A47 North Tuddenham to Easton Dualling

9.12 Additional Information for the Lead Local Flood Authority (LLFA) and the Environment Agency

A47 North Tuddenham to Easton Improvements – Flood Risk Assessment Initial Review

Figure 2-1 Comparison of flood extents along the Oak Farm watercourse pre- and post-development during a 1 in 100 year event with a 65% allowance for climate change

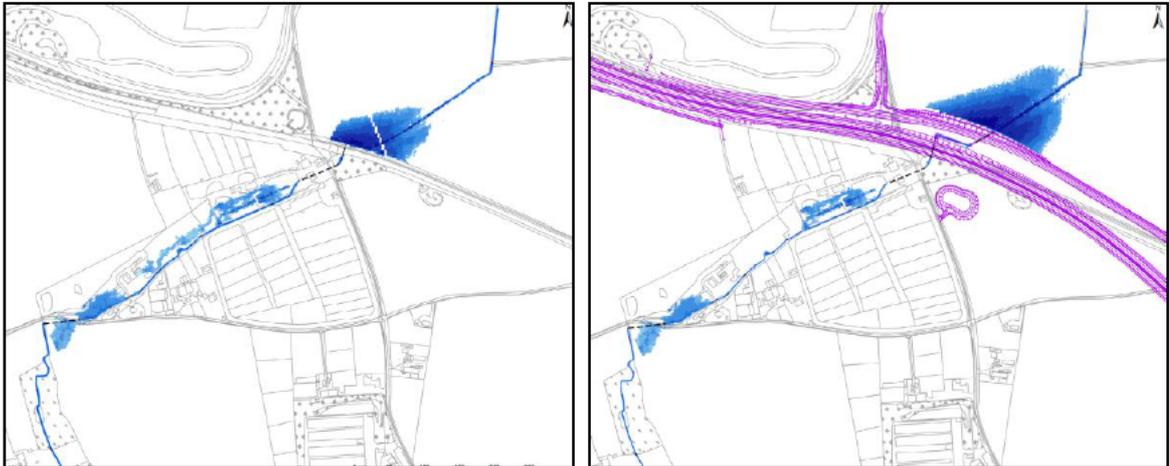
We are glad the proposed scheme at the Oak Farm culvert is able to improve the attenuation of flows through the culvert, reduce the downstream water levels through Oak farm and to retain the water upstream of the culvert while retaining a minimum freeboard in excess of 300mm. The information provided regarding the volume of water accumulated upstream determines the volume of water for the proposed arrangement and future flows. However, the pre-development volume of water accumulated is in a different section of the report to the post development accumulation of water. Therefore, it is not possible to clearly compare the pre and post development volumes as was previously requested in out letter dated 9th February 2021. Please update the FRA to present this information more clearly to clarify the situation.

2.2.3 It can be seen from Figure 2-1 that water pooling south of the existing A47 at Oak Farm has been shifted uphill by the Scheme. It can also be seen that the Scheme stores more water than the present arrangement. Flood extents downstream of the proposed section have been reduced as a result of the additional storage.

2.2.4 It should be noted that the throttling effect of the orifice ensures that there will be an increase in available floodplain volume upstream of the proposed development when compared to the present arrangement, as shown in Table 2-2.

Figure 2-2 – The Oak Farm bund as represented in the hydraulic model

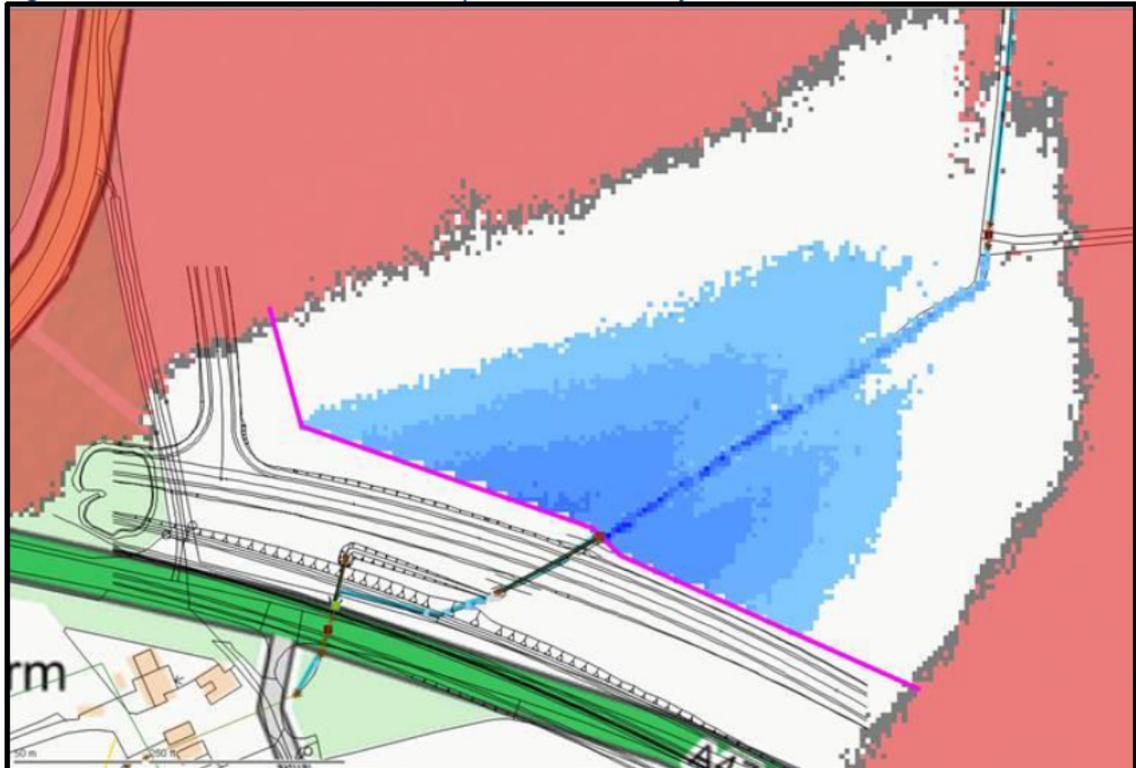
The bund shown on the plan near the junction of the Lynn Road with the connection to the old A47 continues to show that it does not tie into the existing similar ground levels, while the FRA indicates that the bund will tie into ground with similar ground levels. We would continue to recommend that the western extent of the bund is tied into ground of a similar level to ensure mitigation and update the relevant documents to ensure consistency.

2.3.1 The bund crest near the junction of Lynn Road will be level and tie-into existing ground level, the design and drawings will be updated to reflect this in the detailed design stage. The hydraulic model features a bund that has a level crest and ties into existing ground levels; hence the predictions presented in the FRA, with regards to peak water levels and storage volumes, are sound. The representation of the bund in the hydraulic model can be seen in Figure 2-2. It can be seen that the bund, represented as the pink line, ties into a grey contour representing 46.5mAOD – the crest level.

Figure 2-3 Approximate hydrological catchment showing areas of woodland.

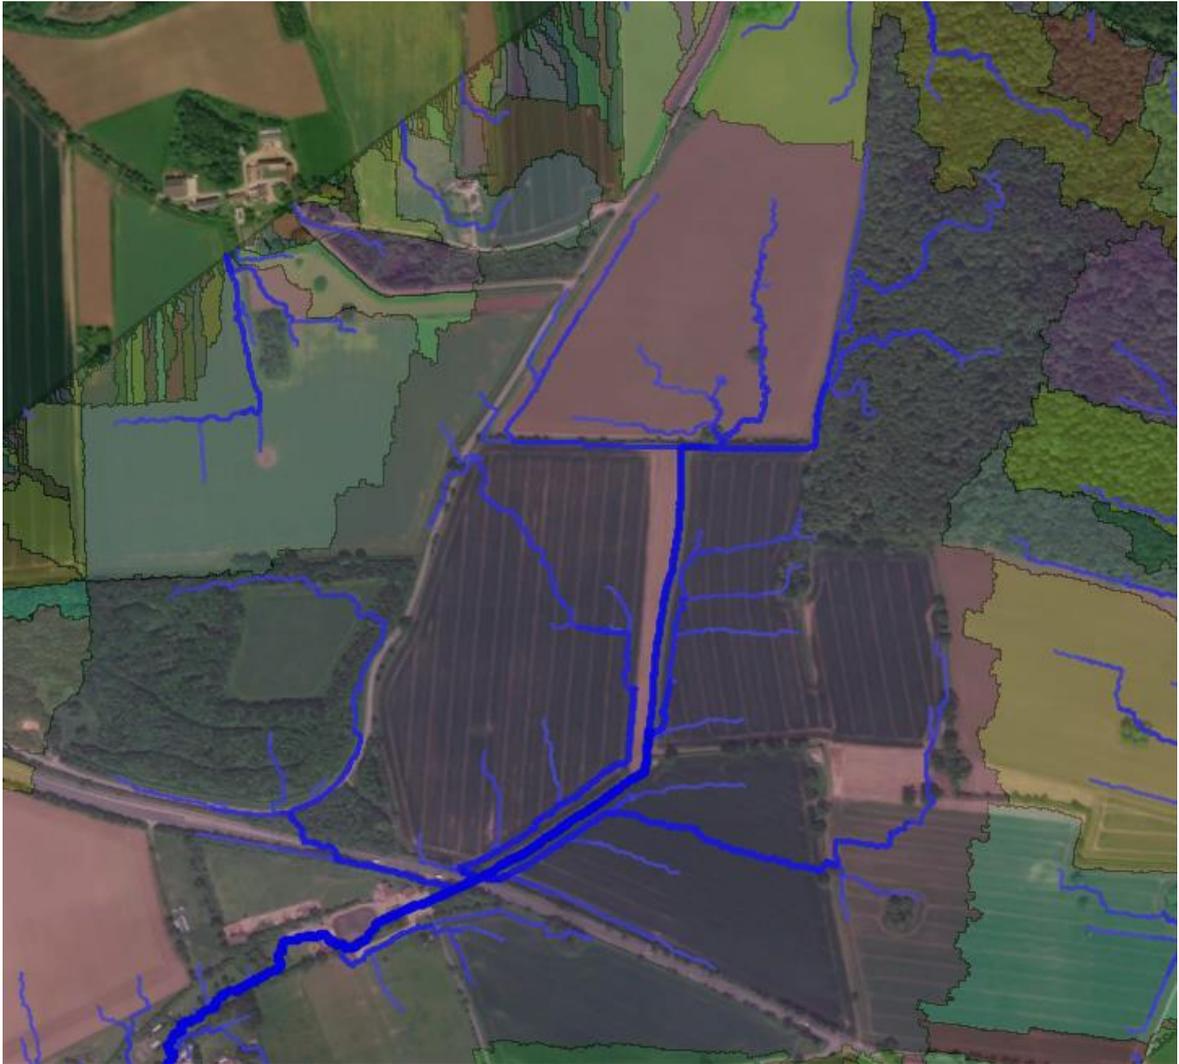
We note that you intend to control flow into the culvert with a 300mm orifice plate, although there is no discussion in the FRA regarding alternative flow control approaches that have been considered or the justification of the orifice plate being selected. The FRA does not report on the assessment of debris for this catchment and whether this is a residual risk present for this control structure and how debris would be managed.

- 2.4.2 Land in the area is sloping at around 1 in 125 and covered with hedge lined positively drained arable farm. Around 0.13km² of deciduous woodland sits in the northeast of the catchment, as shown in Figure 2-3. Around 500m of the stream has woodland on one bank. Noting these factors the blockage potential from upstream debris is estimated to be medium according to Table 7.2 of the CIRIA *Culvert, screen and outfall manual (C786)*.

- 2.4.3 To reduce the risk of blockage the Applicant has specified a screen on the culvert inlet at Oak Farm. The appropriate area of screen will be calculated in the detailed design stage. The screen will have safe access for maintenance such that the screen can be raked following extreme rainfall. Safe vehicle access will also be provided from the proposed new local access road. This access will also be designed in detailed design stage. Freeboard allowance was built into the bund in the event that the screen becomes blinded.
